## BOURGAULT MARKETING - TECHNICAL SERVICE BULLETIN

**TSB # 26-2021** October 27, 2021 Page 1 of 2

SUBJECT: Hydraulic Changes on Bourgault Independent Opener Drills (3330, 3335, 3820, 3720)

Manual Override Screw

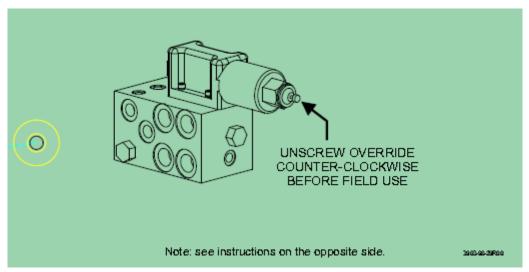
On all model year 2022 drills the openers will no longer raise or lower by simply cycling the opener depth control circuit on the tractor. When these machines are NOT connected to a 410 control box or X30/X35 controller the ONLY way to raise or lower the openers will be to use the manual override on the directional control valve.

A running change will take effect shortly to install an updated tag (part number 3903-98-29) to the directional control valve – which will provide clear instructions.
